HINS - FRONT END ROOM TEMP CH CAVITY B0744 CYLINDER

SCALE	DRAWING NUMBER	SHEET	REV
1:2 & AS NOTED	5520.000-MD-440379	1 OF 1	A

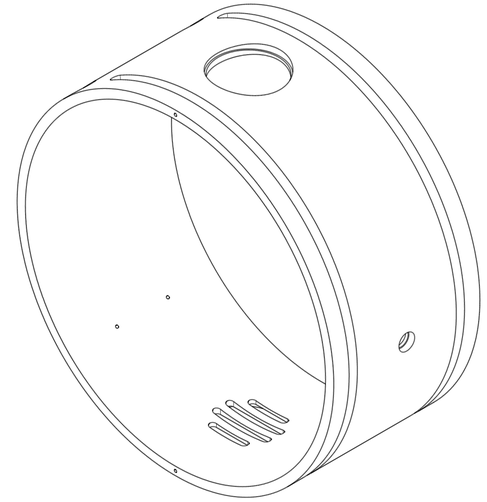
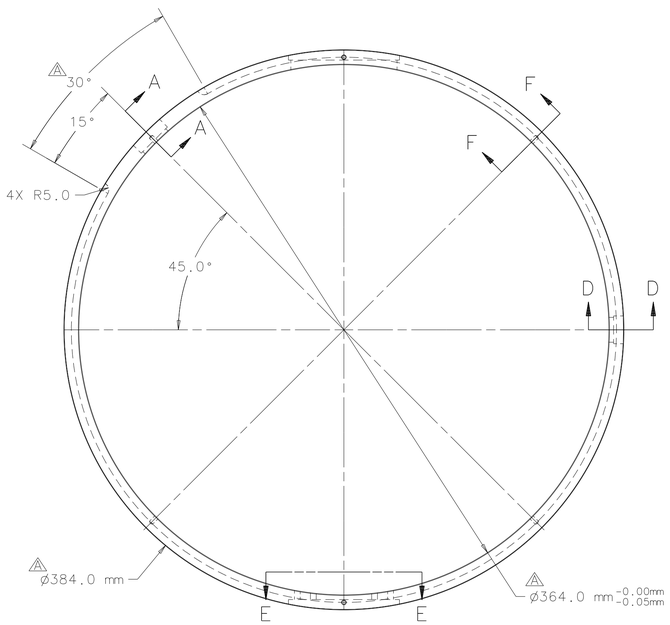
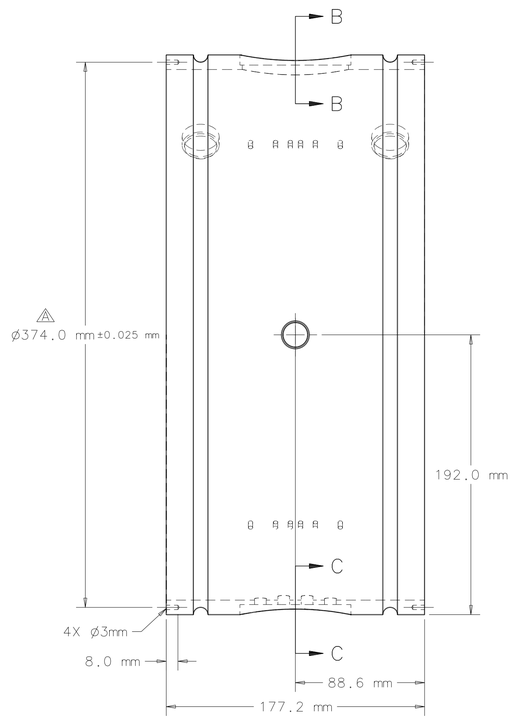
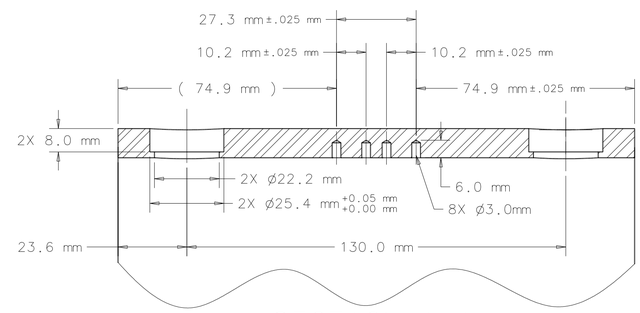
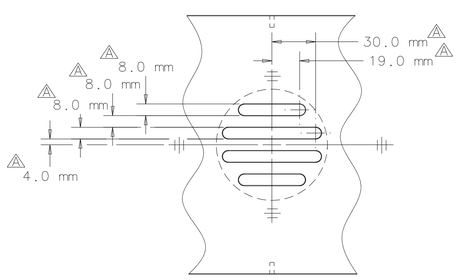
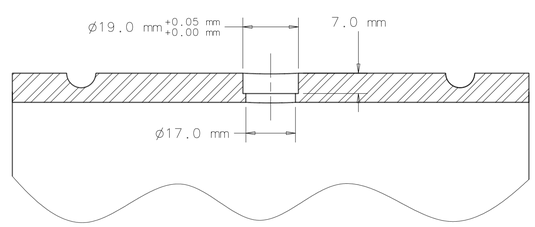
REV	DESCRIPTION	DRAWN	DATE
		APPROVED	DATE
--	NEW RELEASE E.R.# 8271	L. SIMMONS	06-FEB-2006
A	CHANGED SLOT CONFIGURATION & SIZE CHANGED GROOVE CONFIGURATION CHANGED CYL. O.D. WAS: ø385.6 NOW: ø384.0 CHANGED CYL. I.D. WAS: ø365.6 NOW: ø364.0 CHANGED DIMENSION WAS: ø375.6 NOW: ø374.0 CHANGED DRAWING TITLE - WAS: PROTON DRIVER - FRONT END UPDATED DRAWING ECO #8311	L. SIMMONS	31-MAR-2006
		T. NICOL	06-APR-2006
